This is to certify that Bryan Suzanne Gardiner & Bryan Point Inc
has permission to Build 128 sq. Ft addition to room, 2nd floor remodeling and replace steps.
AT 9 Cushman St Portland, OR 97201 056 B017001

City of Portland, Maine - Building or Use Permit Application

Dept: Zoning **Status:** Approved with Conditions **Reviewer:** Jeanine Bourke **Approval Date:** 01/05/2004

Application for Exemption From Building Code Railing Height Requirements

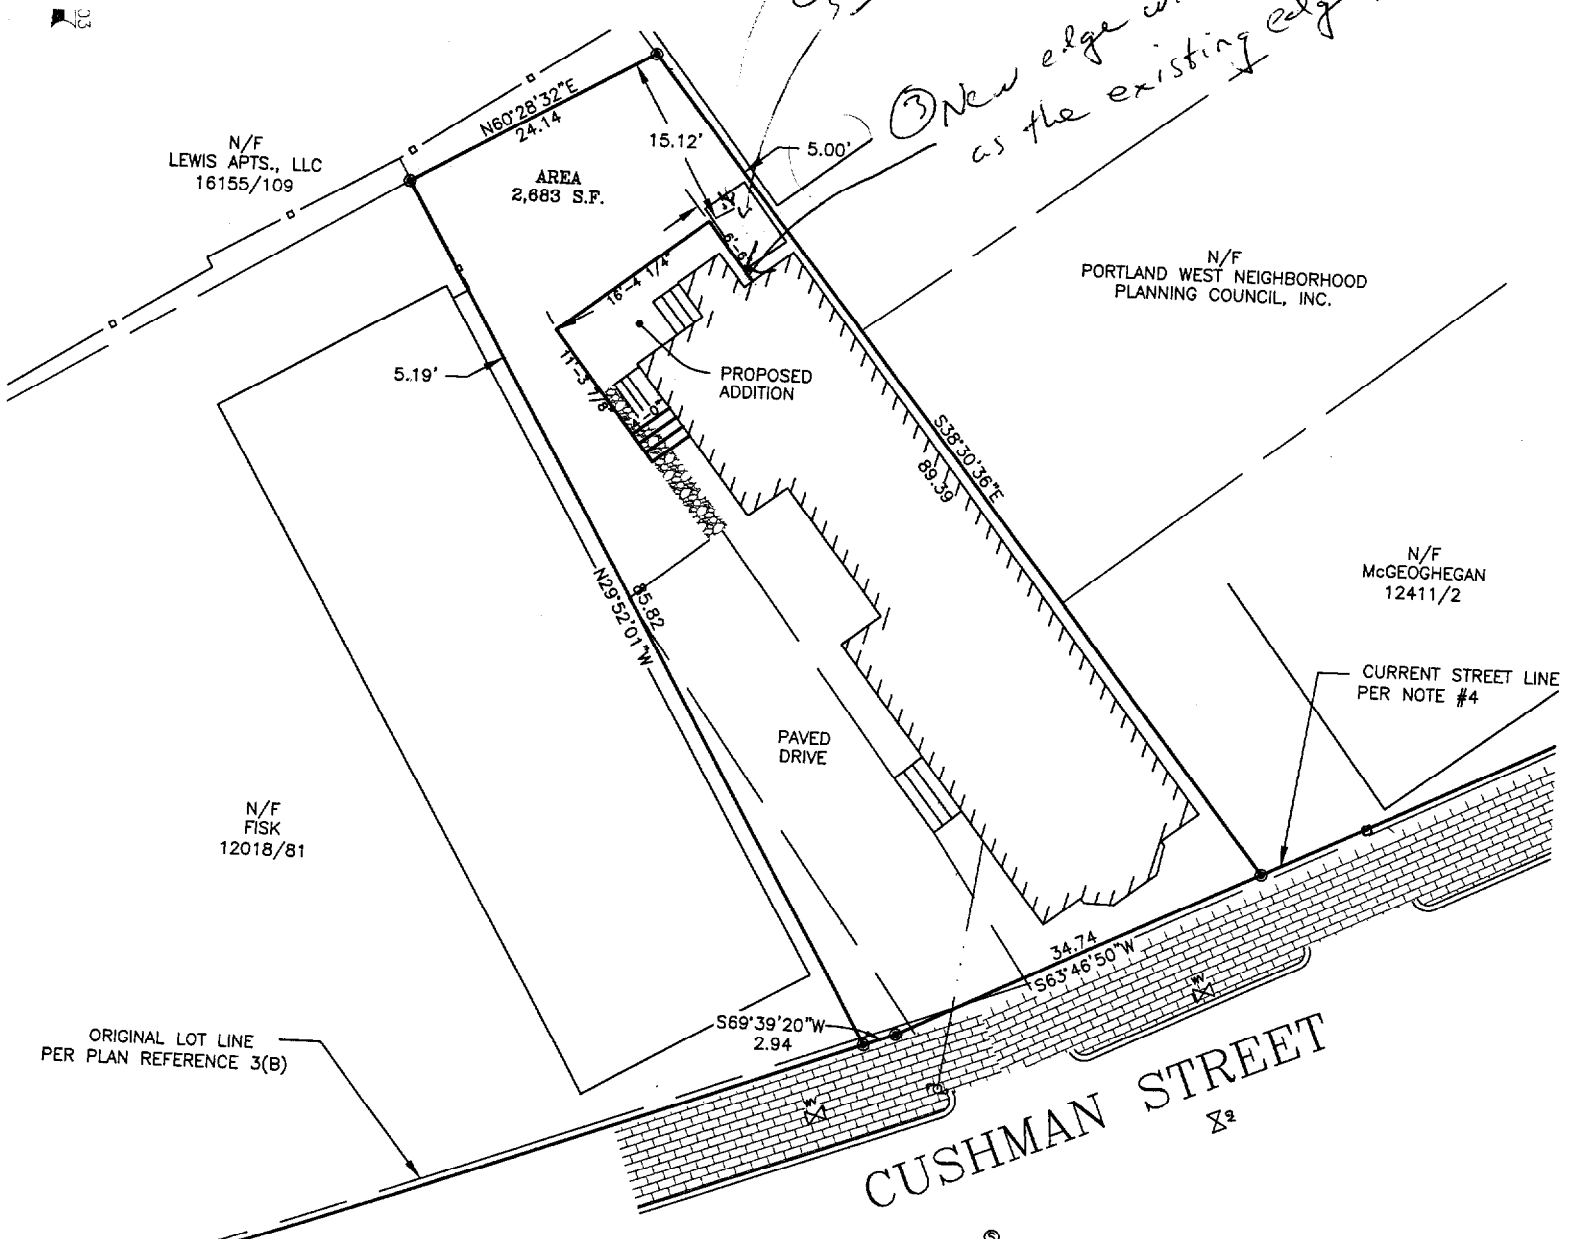
R 6 Zone

Rear 20' Required 15.12' Shown

Side 10' Req 5.19 & 5' Shown

Sec. 14-433 allows a setback reduction to min. 5' Rear/sides

Right side will not extend further than the existing porch

① Overhang will not occur

② Shed will be moved or removed

③ New edge will be the same as the existing edge.

9 Cushman St.
Step Details - Front Entrance

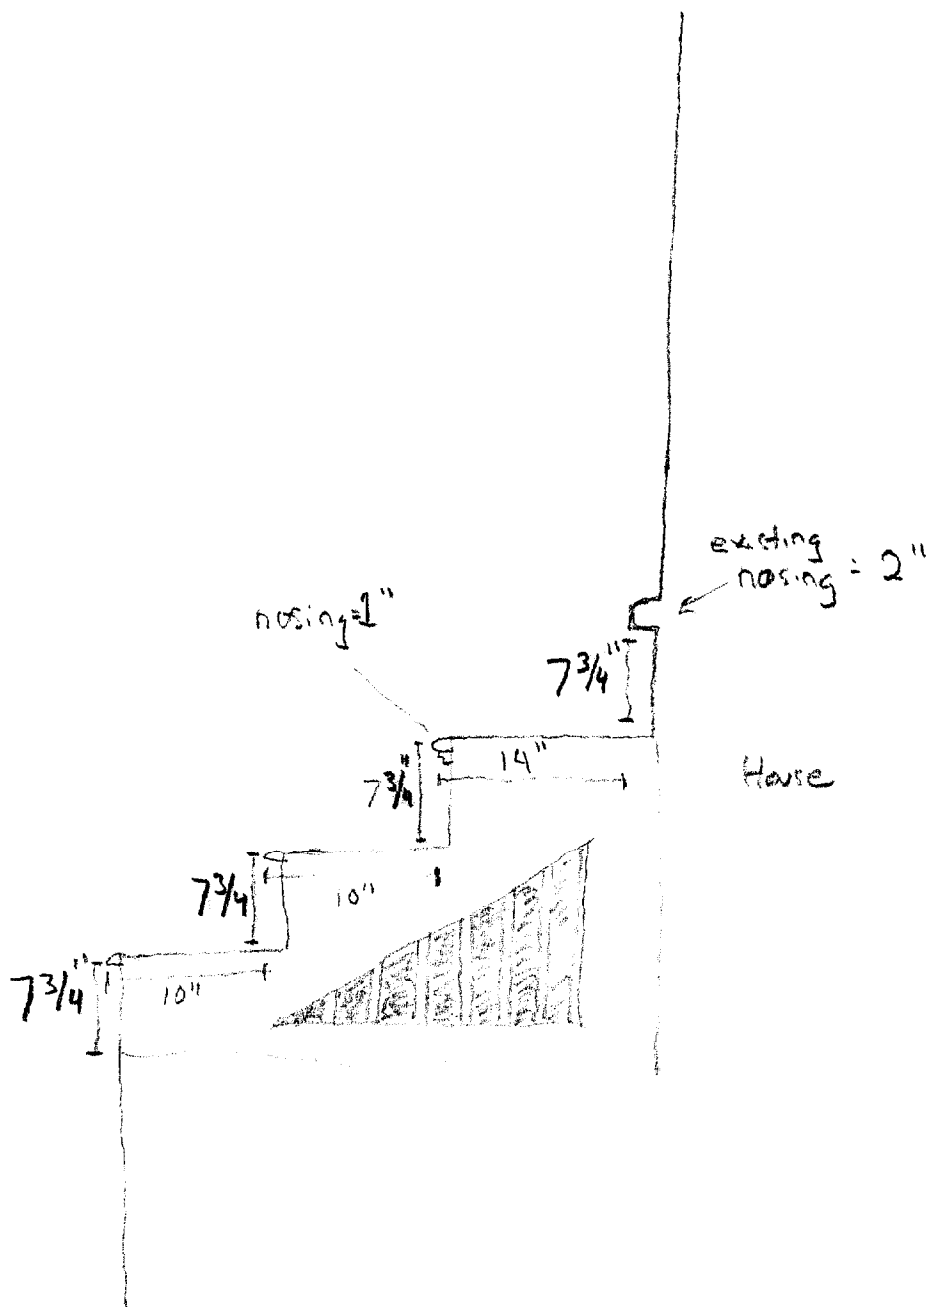
- 3) The height of the top step is 24" above grade. While a fall from any height can result in injury, a two-foot fall is much easier to manage than one from a higher set of stairs. (See accompanying photocopy – Exhibit 1)

- 4) The width of the stairs is 67." Any handrails would be far enough away from the center of the door and mail slot that their use would be unlikely. (See accompanying photocopy – Exhibit 1)

- 5) The placement of handrails on the front steps would result in a dramatic alteration of the historic look of this landmark building. (See accompanying photo – Exhibit 2)

Historic Preservation Committee/Staff Recommendation: Committee Staff recommend
no railing at these steps - per instructions
for original construction. 1/22/04

Inspections Staff Recommendation: OK PER SECTION 3406
OF BOCA CODE

9 Cushman St.
Stair Details - Basement

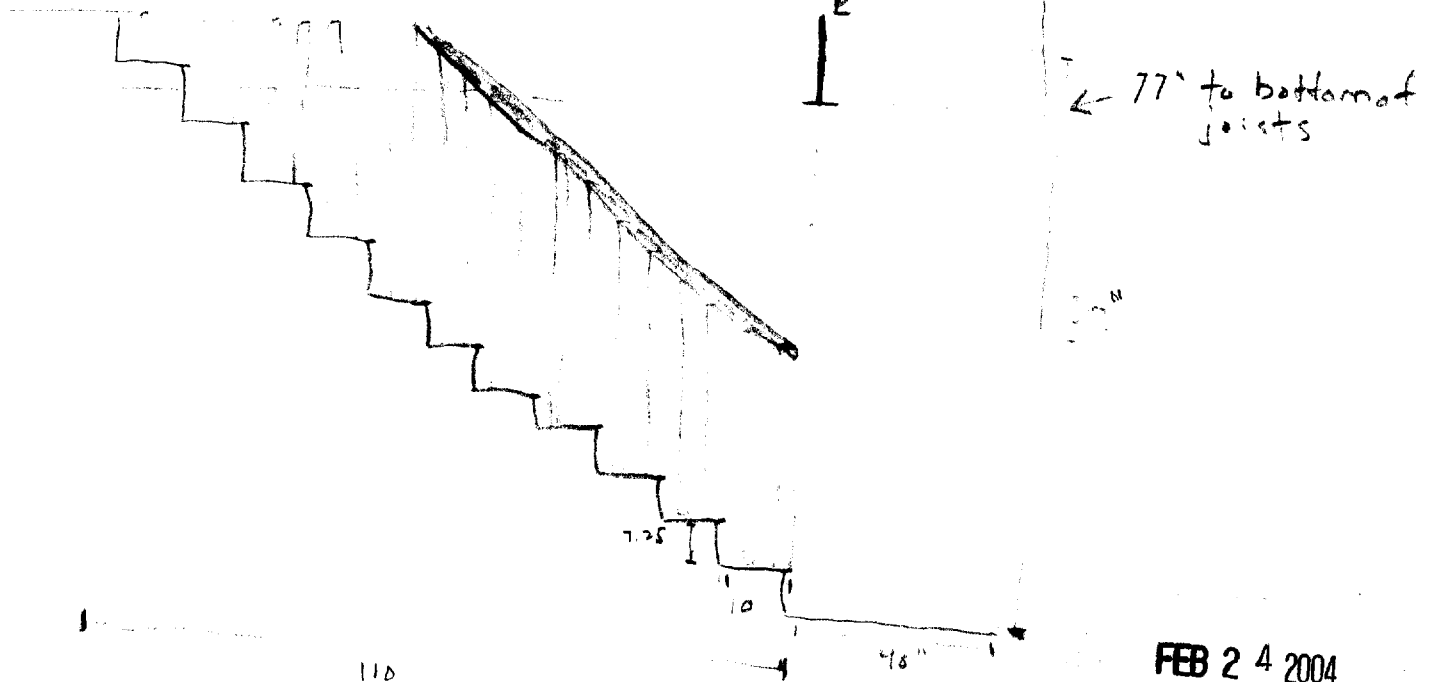
This area opens up and clearance will not be an issue

Clearance will be 69 3/4".

**BASEMENT
STAIR
DETAIL**

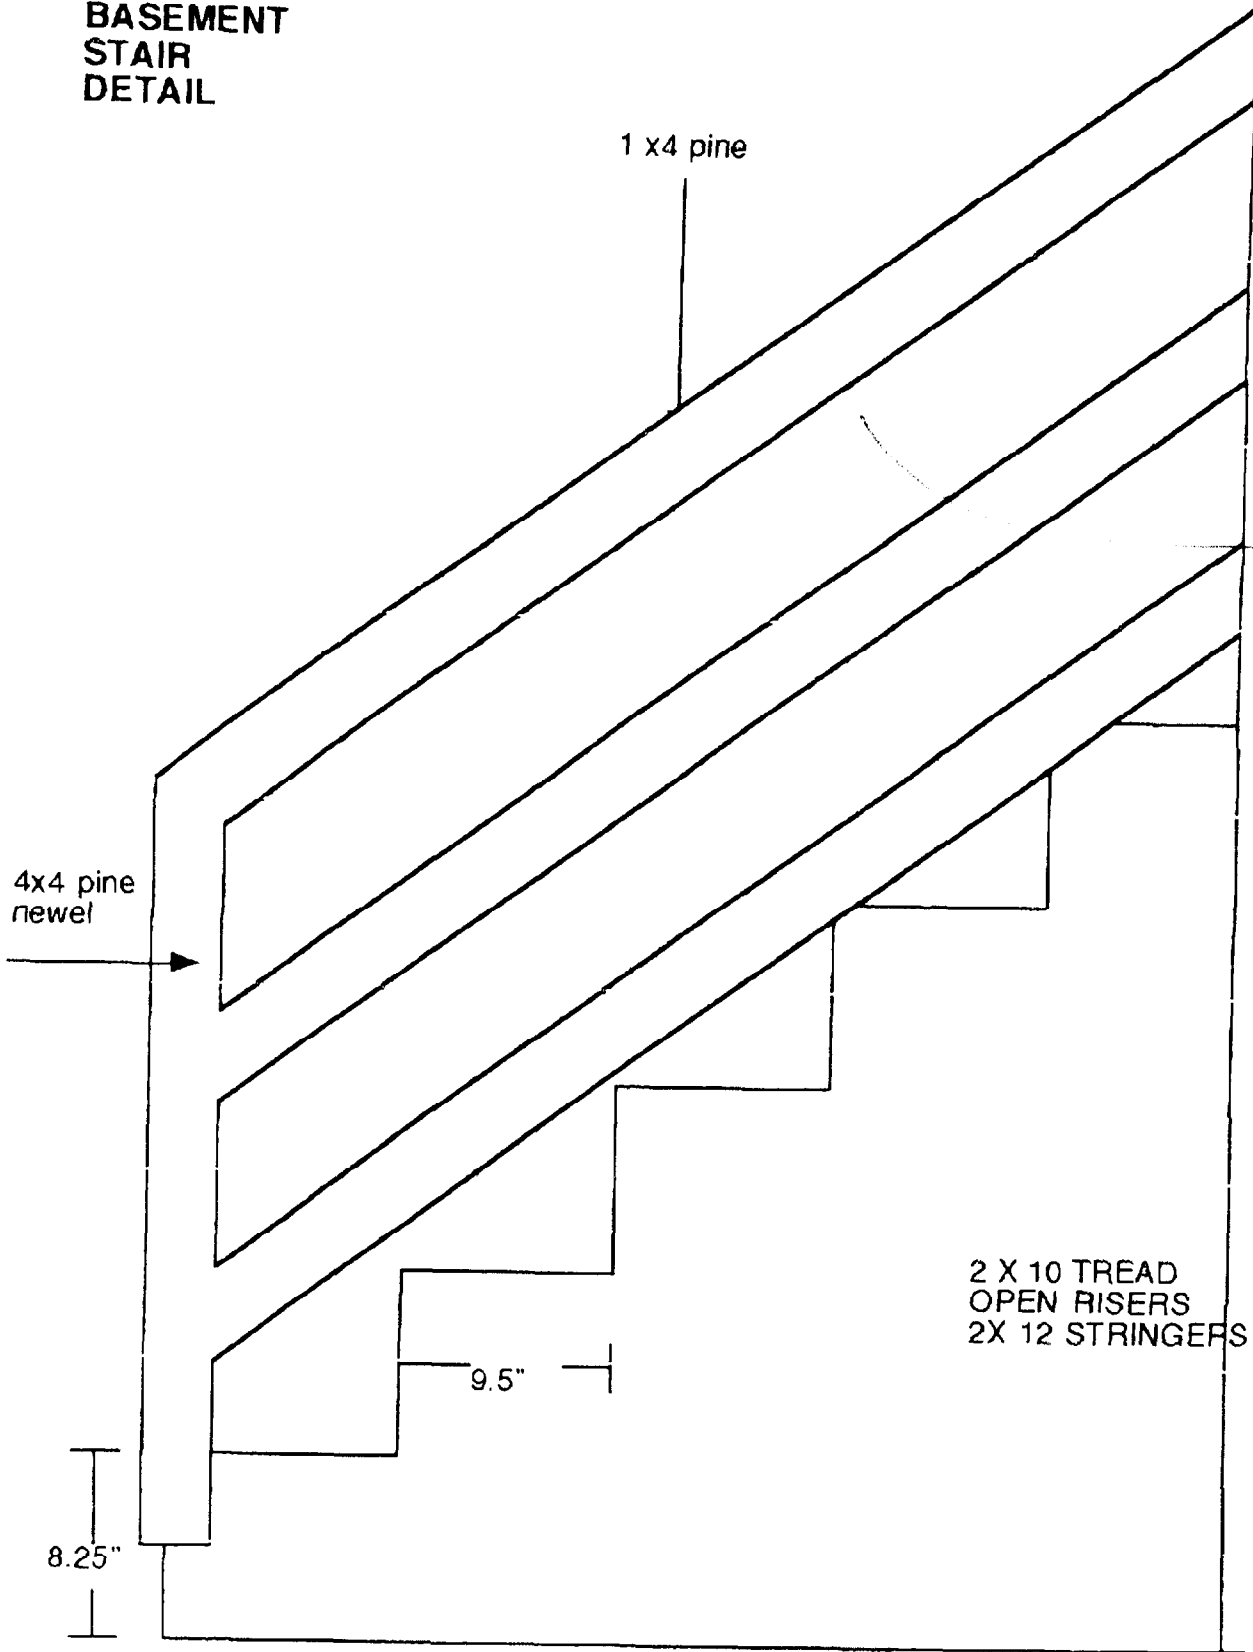
*Not to
code*
